APPLICATION NO.	FILING DATE	FIRST NAMED INVENTOR	ATTORNEY DOCKET NO.	CONFIRMATION NO.
10/655,921	09/05/2003	Kristine A. Maniscalco	03112	8619

Office Action Summary	Application No. 10/655,921	Applicant(s) MANISCALCO ET AL. 	
	Examiner Andrea M. Valenti	Art Unit 3643

DETAILED ACTION

FIG. 7.

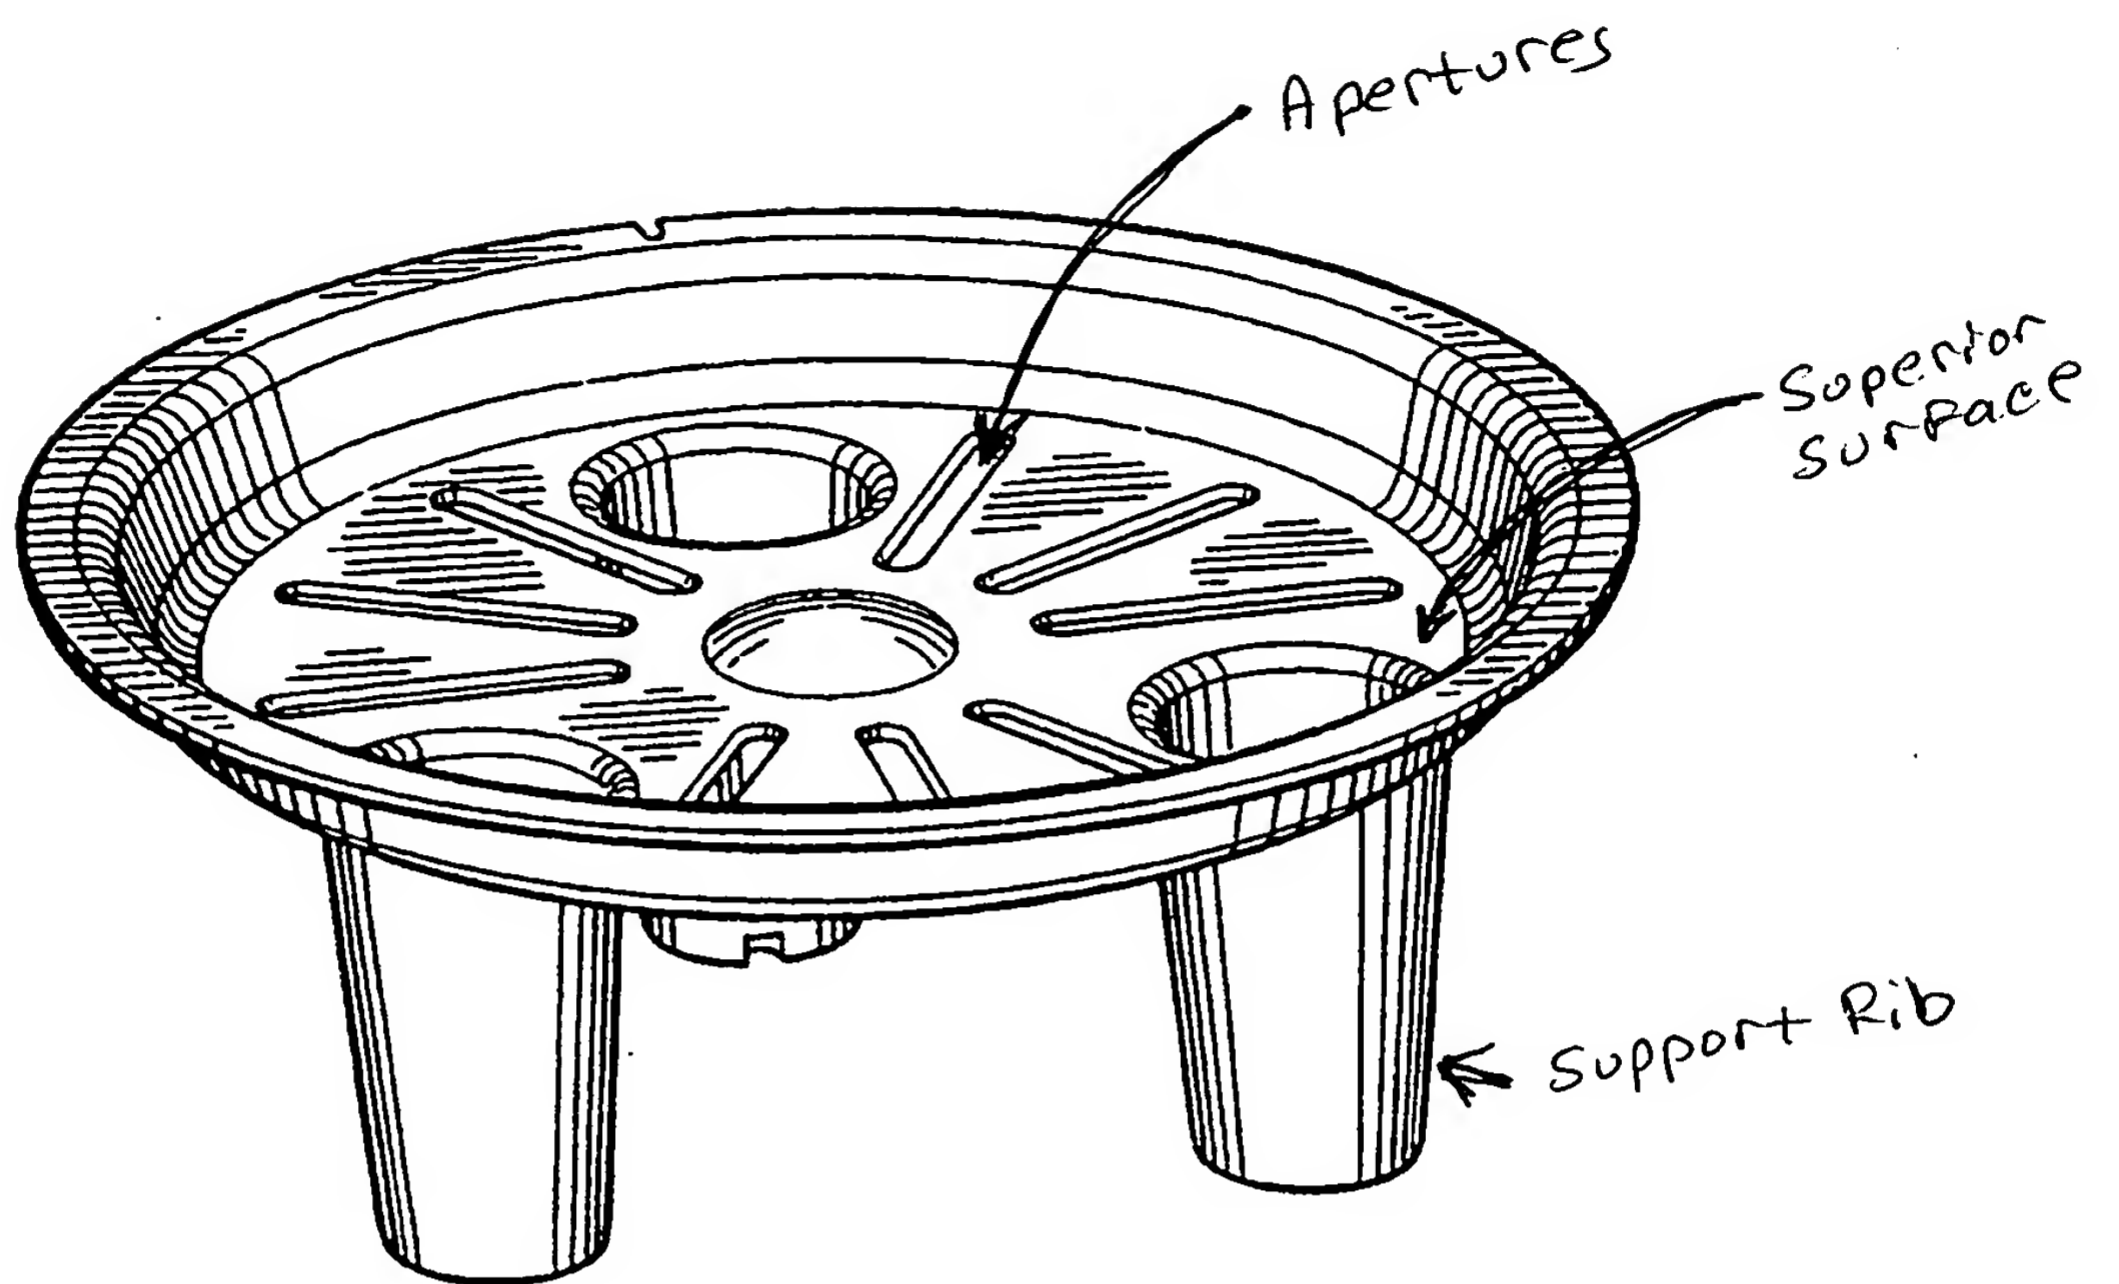
extending from the container bottom to the container rim, the inner container surface having a select container periphery intermediate the container bottom and the container rim (Fig. 2); the container insert comprising: a substantially planar superior support surface, a substantially planar inferior support surface, a peripheral support ridge, a plurality of support ribs, and a plurality of matter - receiving apertures, the peripheral support ridge comprising a sloped peripheral support surface and a peripheral support rim, the peripheral support surface being intermediate the superior support surface and the peripheral support rim, the peripheral support surface having a container - engaging depth, the support ribs being integrally formed to the inferior support surface and substantially equally spaced from one another, the matter - receiving apertures being spaced intermediate the support ribs and extending from the superior support surface to the inferior support surface, the peripheral support surface being in removably wedged engagement with the select container periphery, the container insert thus forming a false bottom in the oversized planter container at the select container periphery (please see attached Fig. 7 and 8).

Regarding Claim 32, Carlson teaches the matter - receiving apertures are defined by at least one moisture drain aperture (Fig. 7).

FIG. 8.

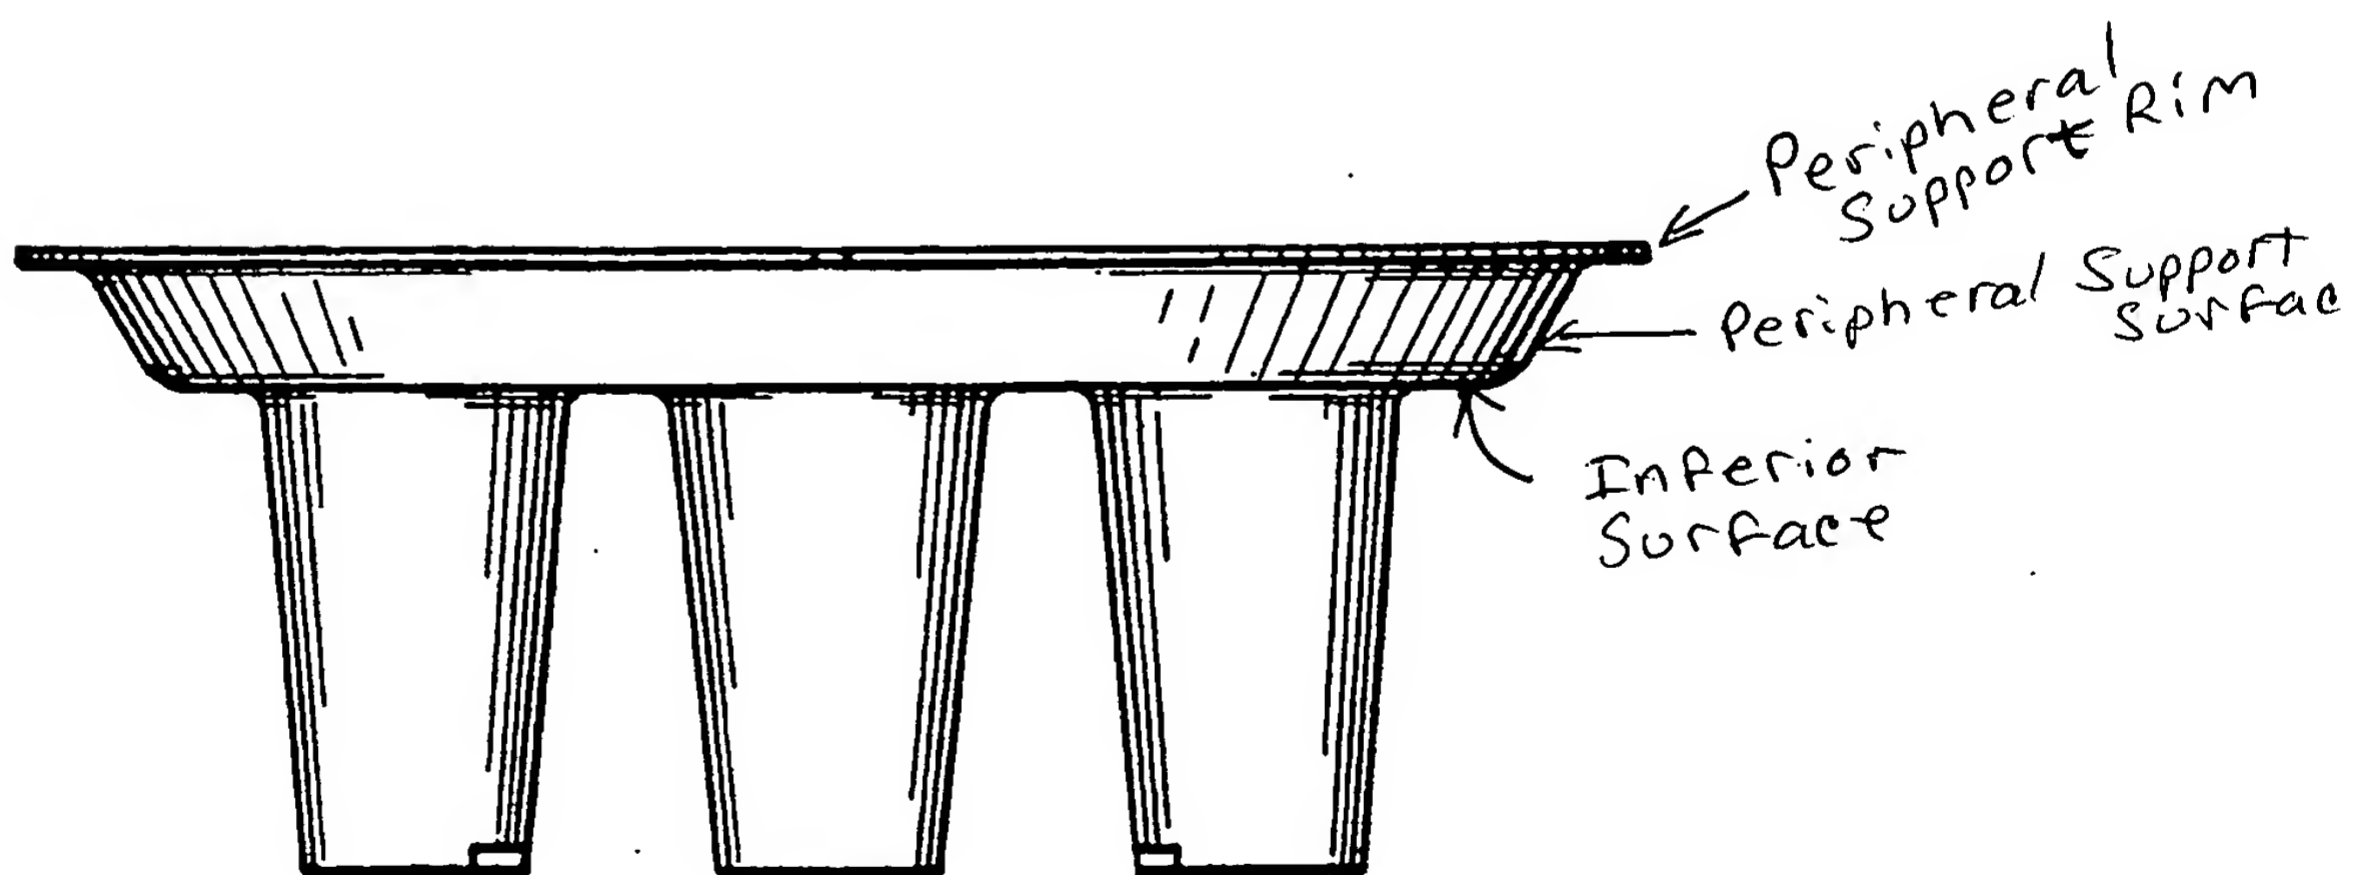
Regarding Claim 36, Carlson teaches the container insert comprises in combination manual removal means for enabling a user to manually remove the container insert from engagement with the select container periphery (Fig. 8).
